Access Audit Site Report

Galveston Island State Park

Accessibility Evaluation

Inspection Date: 08/17/2022

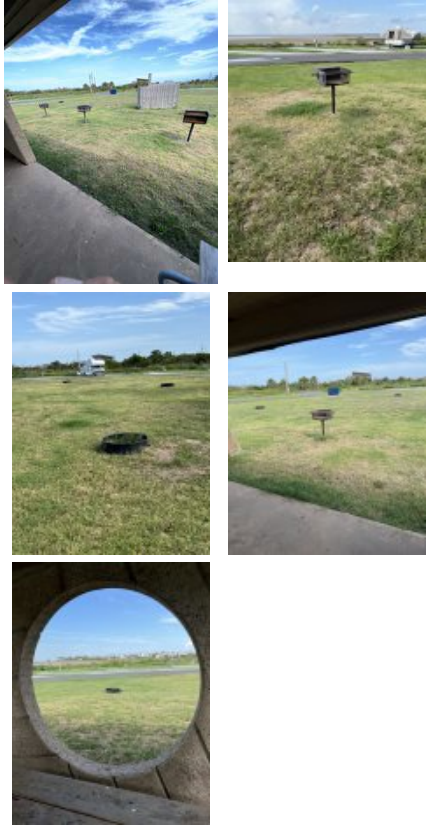
Finding Number	Area Description	Lat/Long	Finding	As Built	Recommendation	Citation	Photos	Figure
188	Bayside - Oak Bayou Area: Oak - Canoe/Kayak Launch	[29.2048132 , -94.957044 5]	There is no accessible route to the canoe/kayak launch. At least one accessible route shall connect accessible buildings, accessible facilities, accessible elements, and accessible spaces that are on the same site.	Gravel before boardwalk	Create an accessible route with crushed stone or other outdoor material from parking or walkway to canoe/kayak launch.	2015 ABAAS Section: F206.2.2 2012 TAS Section: 206.2.2 2010 ADAS Section: 206.2.2		
189	Bayside - Oak Bayou Area: Oak - Canoe/Kayak Launch	[29.2048244 , -94.957036 3]	The walkway contains abrupt vertical edges and/or variations over a 1/4 inch. 1/4 inch is the maximum vertical rise. Changes in level between 1/4 inch and 1/2 inch must be beveled at 1:2 or less. Changes in level greater than 1/2 inch must be by way of a ramp.	Large drop to sand surface	Repair, bevel or ramp change in level along accessible route.	2012 TAS Section: 303.2, 303.3 2010 ADAS Section: 303.2, 303.3

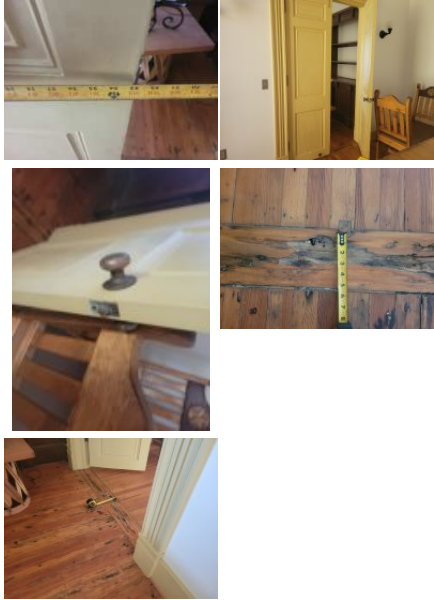
Finding Number	Area Description	Lat/Long	Finding	As Built	Recommendation	Citation	Photos	Figure
225	Bayside Area: Bayside - Women's Restroom	[29.2104175 , -94.954965 7]	The water and drain pipes under the lavatory are not adequately insulated. Water supply and drain pipes under lavatories and sinks shall be insulated or otherwise configured to protect against contact. There shall be no sharp or abrasive surfaces under lavatories and sinks.	pipes lack insulation	Insulate exposed pipes under one sink.	2015 ABAAS Section: 606.5 2012 TAS Section: 606.5 2010 ADAS Section: 606.5		
226	Bayside Area: Bayside - Women's Restroom	[29.2104339 , -94.954960 3]	The baby changing table is not compliant. Baby changing tables are work surfaces. If fixed or built-in baby changing tables are provided, at least 5%, but not less than one, must comply with TAS 902 based TAS 226.1. Baby changing tables cannot violate the protruding object requirements in either an open or closed position since either position is a potential hazard for persons with visual impairments. Baby changing tables are not prohibited from being located in wheelchair accessible toilet compartments; however, the minimum space required for the compartment cannot be obstructed by the baby changing table in either an open or closed position. The clear floor space required for a baby changing table may overlap the water closet clearance since baby changing tables are considered convenience "fixtures" based on Advisory 604.8.1.1. The overlap is applicable only to the clear floor space and not to actual table itself. Baby changing tables must be dispersed throughout a space, however, an additional baby changing table is not required in a common use area of a toilet or bathing room when the only baby changing table is located in a toilet compartment.	Changing station projects when open	Relocate baby changing table to eliminate protrusion when in the open position. Place cane detectable warning on sides of baby changing table.	2012 TAS Section: 226.1, 902.3, 604.3.2, 204.1, 226.1 Advisory, 226.2, 307.1, 604.8.1.1 Advisory, 902.1, 902.1 Advisory, 902.2

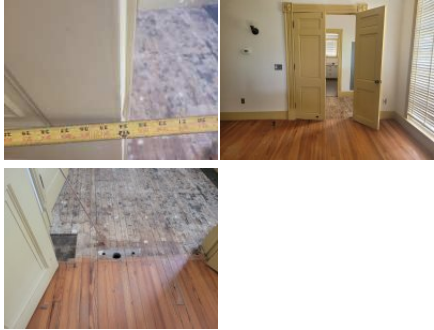
229	Bayside Area: Stewart House	[29.2090901 , -94.952916 4]	The ramp slope exceeds the maximum running slope (direction of travel) allowable of 8.33%. Ramps should have the least possible slope but in no case more than 8.3% (1:12).	8.9% top run, 9% on boards bottom run, 9.2% concrete bottom run	Correct slope of ramp to max 8.33%.	2015 ABAAS Section: 405.2 2012 TAS Section: 405.2 2010 ADAS Section: 405.2

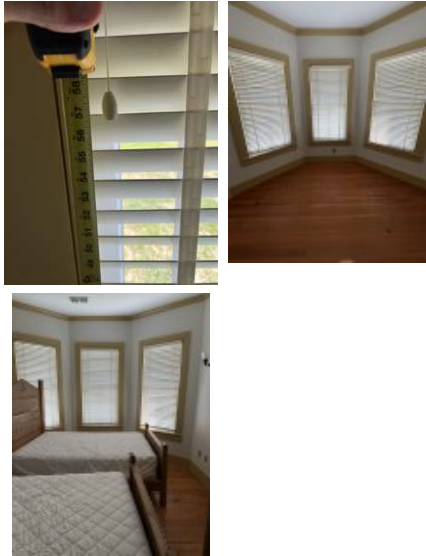
248	Bayside Area: Stewart House	[29.20912, -94.95286]	The rear grab bar is not 36" long or is not mounted in the correct location. The rear grab bar must be a minimum of 36" long and extend from the toilet centerline a minimum 12" towards the wall side and a minimum 24" towards the open side of the toilet. Grab bars shall be installed in a horizontal position, 33 inches minimum and 36 inches maximum above the finish floor measured to the top of the gripping surface and the space between the grab bar and the top of the tank shall be 1-1/2 inches minimum.	Rear bar 15" at toilet centerline, lacks 24" to open side, limited due to door	Leave as is rear grab bar until renovations occur	2015 ABAAS Section: 604.5.2 2012 TAS Section: 604.5.2 2010 ADAS Section: 604.5.2

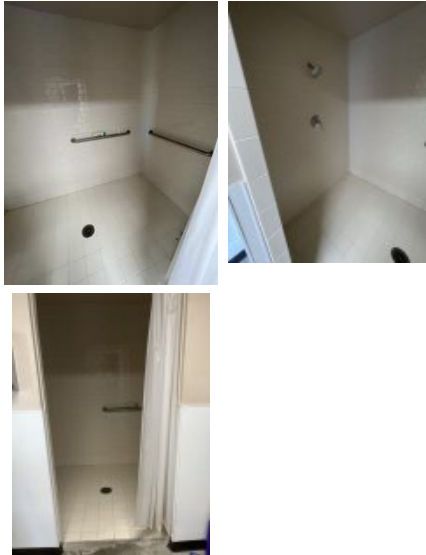
278	Employee Areas: Maintenance	[29.2064902 , -94.9548847]	Spaces and elements within employee work areas shall only be required to comply with 206.2.8, 207.1, and 215.3 and shall be designed and constructed so that individuals with disabilities can approach, enter, and exit the employee work area. Employee work areas, or portions of employee work areas, other than raised courtroom stations, that are less than 300 square feet (28 m2) and elevated 7 inches (180 mm) or more above the finish floor or ground where the elevation is essential to the function of the space shall not be required to comply with these requirements or to be on an accessible route.	Laundry - garbage can push side, dryer and shelf pull side	For employee spaces, relocate storage, furniture, and other obstacles at doorways to provide approach, enter and exit at the employee space. Provide required maneuvering clearance on push and pull side of doors.	2015 ABAAS Section: F203.9 2012 TAS Section: 203.9 2010 ADAS Section: 203.9

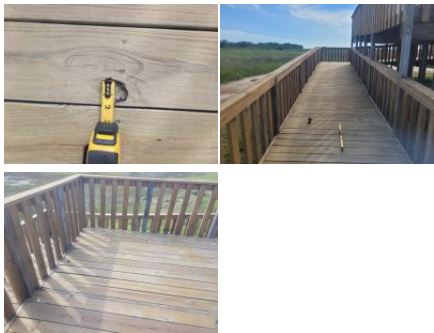
Finding Number	Area Description	Lat/Long	Finding	As Built	Recommendation	Citation	Photos	Figure
290	Employee Areas: Maintenance	[29.2064298, -94.9549978]	There are no accessible bathing or shower facilities. Where facilities for bathing are provided for the public, clients or employees, including showers or bathtubs, at least one shower or bathtub and support facilities such as lockers, and not less than 1 percent of all facilities, shall be accessible.	Shower is not accessible, large space with grab bars on far wall opposite control wall	Create an accessible shower in locker/bathing room	2015 ABAAS Section: F213.3.6 2012 TAS Section: 213.3.6 2010 ADAS Section: 213.3.6
